STATE OF NORTH CAROLINA
DEPARTMENT OF TRANSPORTATION

March 31, 2008

Subject: **Application for Section 404 Individual Permit and Section 401 Water Quality Certification,** Improvement of SR 1306 (South Mebane St.) from SR 1158 (Huffman Mill Road) to NC 54 (Chapel Hill Road), Alamance County, Federal Aid No. STP-1306(8), State Project No. 8.2473101, Division 7, TIP U-3303A and U-3303B.

Permit Drawing
Sheet 6 of 13

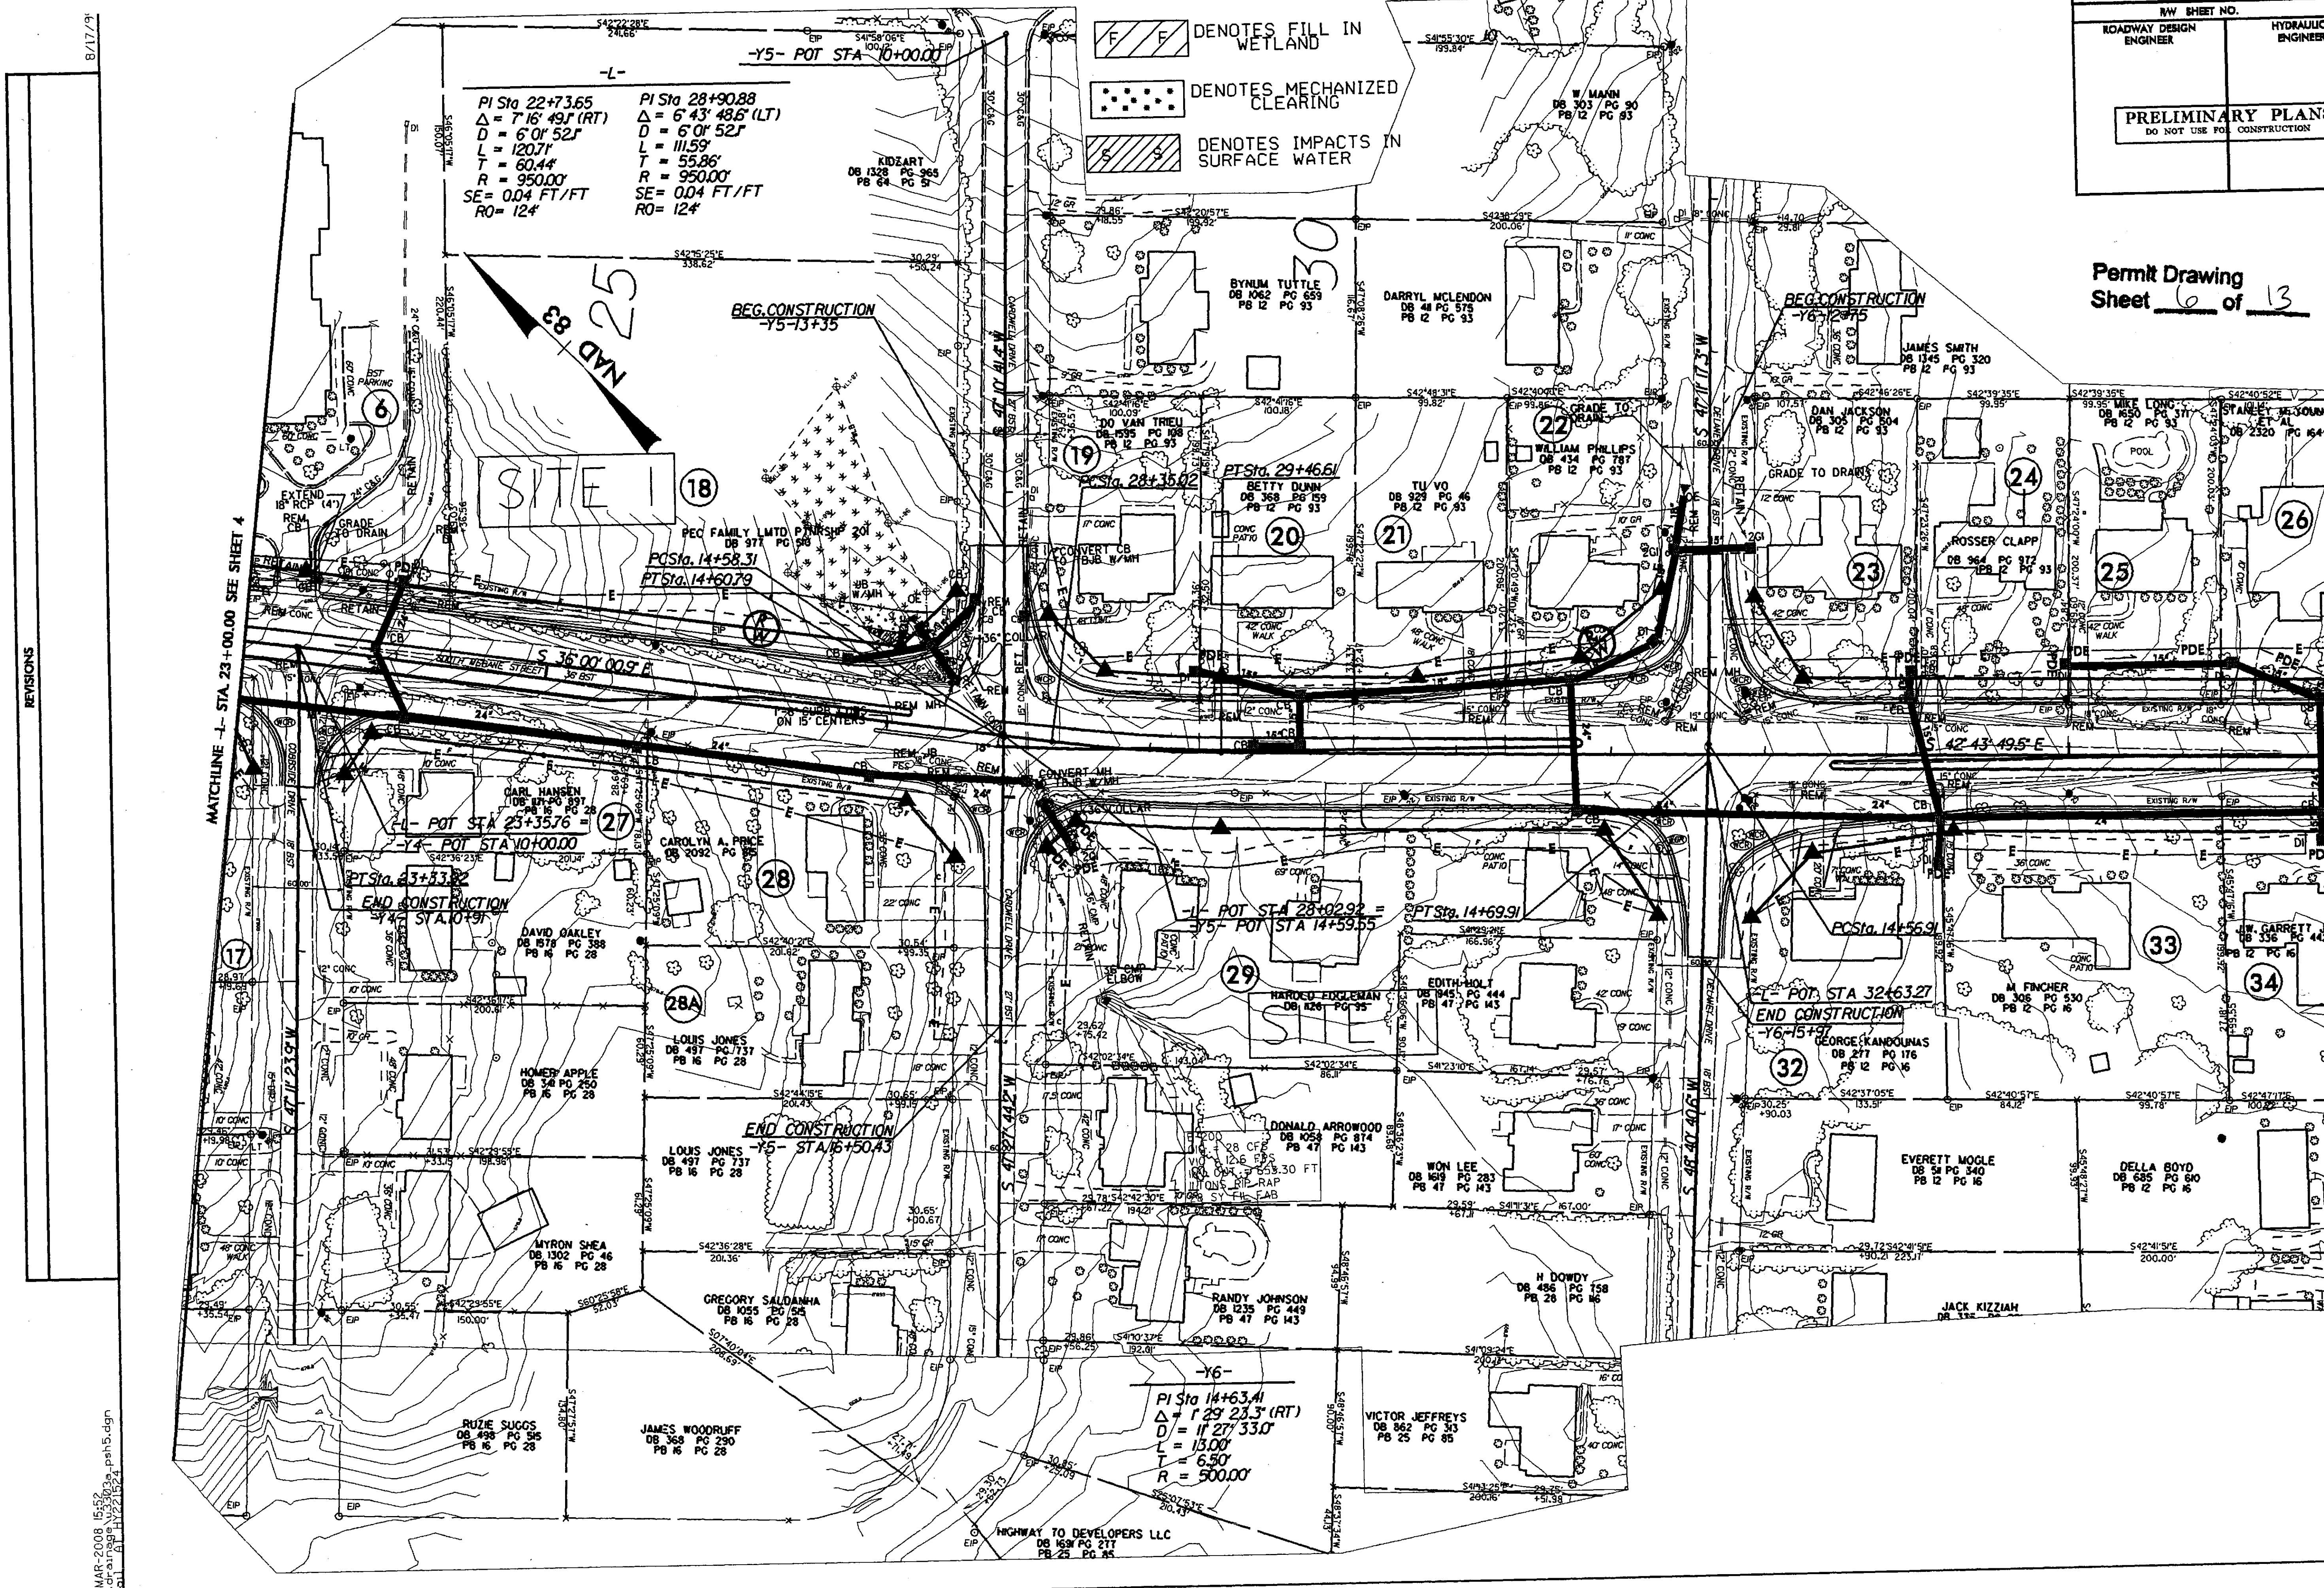
A comment was made about the pipe alignment(realignment) on sheet 6 and/or whether a stream relocation is practical. It was stated the stream relocation and improved pipe alignment would be reviewed in more detail. However, at this time a stream realignment does not seem practical at this location considering the proximity of culverts, up and downstream, and the presence of extensive housing.
